**O'Connell Street Public School
SSD 7372 MOD 5 – Revised Design
Statement of Heritage Impact - Addendum**

I am writing in support of the shade structure proposed at O'Connell Street Public School, adjacent to Building B within the north-west corner of the site. The works are within the State Heritage Register curtilage of the Marsden Rehabilitation Centre Group (Former King's School) SHR 00826. This letter should be read in conjunction with the Statement of Heritage Impact which accompanied the original proposal.

Site Plan, original proposal, December 2018, Northrop.

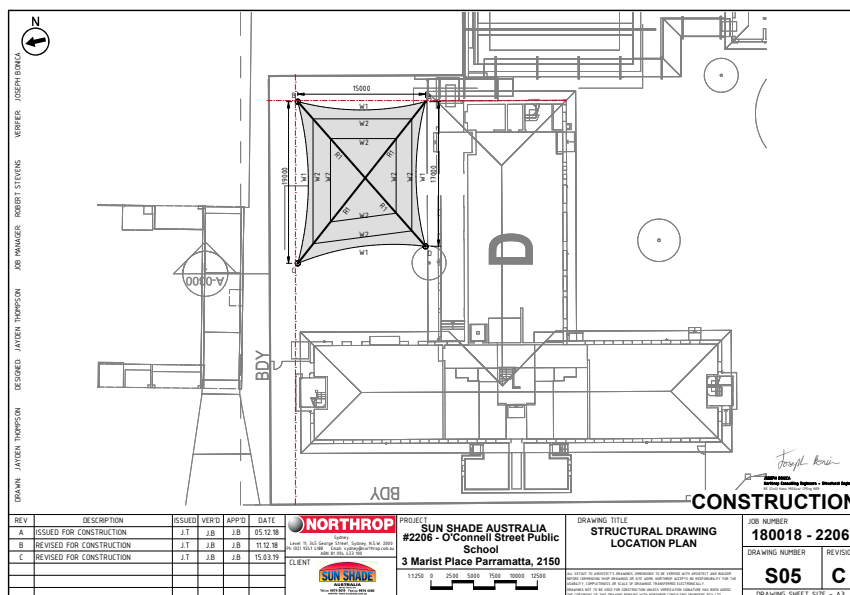
The shade sails would largely not intrude into significant views to, and across, the site, but the extension of the structure beyond the northern building line of the former dormitory would increase the visibility of the structure from O'Connell Street and is not supported. Existing vegetation along O'Connell Street may provide some screening, but to further mitigate adverse impacts, the shade structures should not extend beyond the northern building line of Building D;

The size of the shade structures is to be reduced so that they do not extend further north than Building D.

The size of the shade structures is to be reduced so that they do not extend further north than Building D.

In response to OEH's comments, the design has been revised so that the structure does not extend beyond the northern boundary of Building D, further mitigating any potential heritage impacts. Further the number of sails has been reduced from two to one as illustrated by the site plans shown overleaf.

The shade structures have been reduced to a single structure and do not extend further north than Building D. This condition is acceptable.

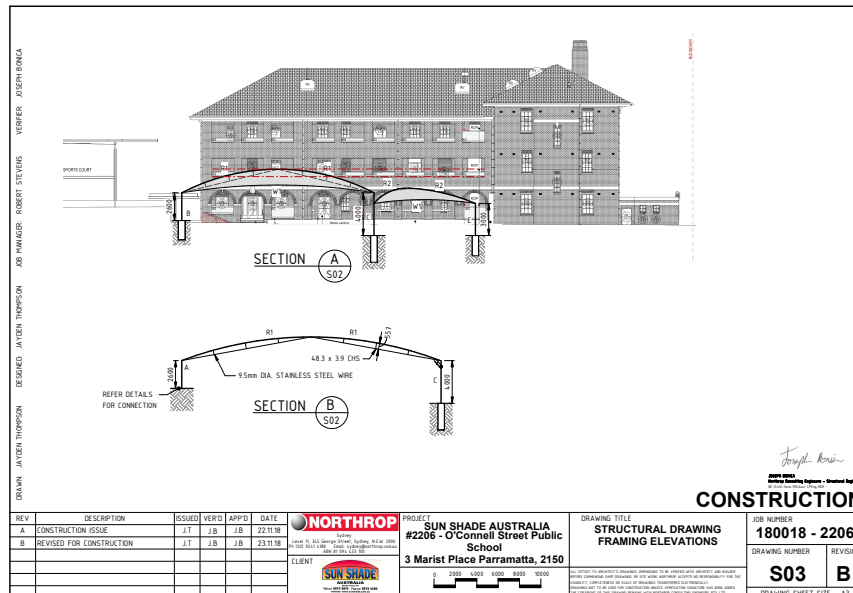
Whilst OEH were supportive in terms of the simple modern curved form of the proposed shade sail they recommended that the height be reduced to sit below the first floor openings.

The height of the main shade sail appears excessive, rising above the first-floor openings, with a curved roof that is unsympathetic to the formality and horizontal lines of Building D. Whilst it is acknowledged that the structure is relatively simple and modern - which is positive - the negative impacts to the character and setting of the building could be mitigated by reducing the height of the main sail to sit below the first floor openings, and corresponding more closely to the height of the triangular sail. A flatter sail may help reduce the height whilst still accommodating the topography;

The design has been revised to reduce the height of the shade sail structure by 700mm at the ridge, however, it is not possible to reduce the height of the ridge to sit below the first floor windows as requested by OEH. This is due to the minimum height of 2100mm at the eastern side and the topography of the site as illustrated below.

Sectional Elevation, original proposal, December 2018, Northrop.

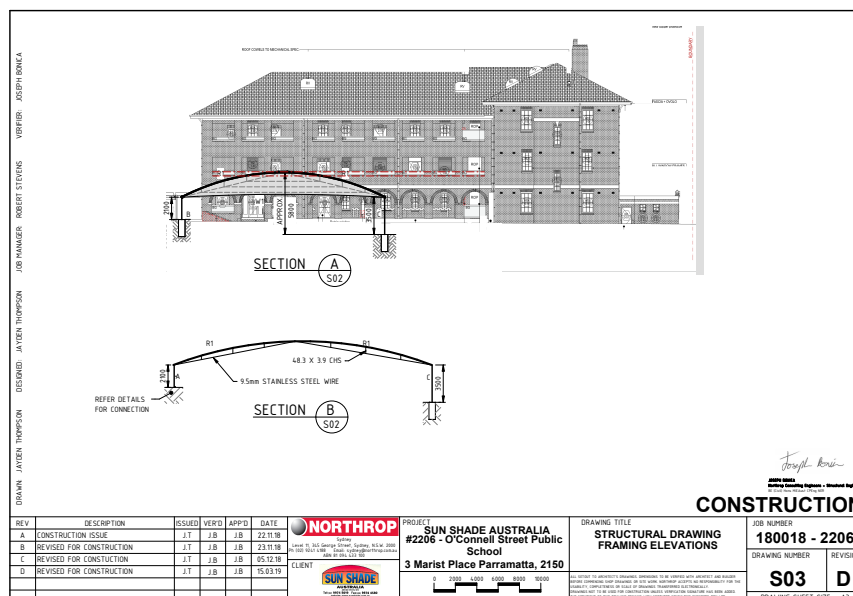
The large shade sail is to be reduced in height to sit below the first-floor openings.

Consideration should be given to a flatter sail design which corresponds more closely to the height of the triangular sail.

The shade structure is substantially lower than the first floor windows at the edges, adjacent to the building and has been designed to read as a distinctly contemporary reversible element within this historic context. The height at the ridge of the large sail has been substantially reduced and now corresponds with the height of the infill balustrades to the first floor openings beyond. The smaller sail has been removed from the proposal. The revised proposal is supported from a heritage perspective.

The large sail structure has been reduced in height by 700mm at the ridge, however cannot sit below the first floor openings due to the 2100mm minimum height restriction at the edges and structural design criteria. The revised design is substantially lower than the original proposal and is considered acceptable from a heritage perspective.

The triangular sail has been removed from the proposal. A flatter sail design was considered in developing the revised proposal, however proved impractical. This is because the density of the fabric required to provide high UV protection must be installed to falls to ensure that any water is able to quickly run off, especially in heavy rain. If the sail was flatter the fabric would stretch and sag from the weight of water and not drain correctly. The fabric cannot be installed flat.
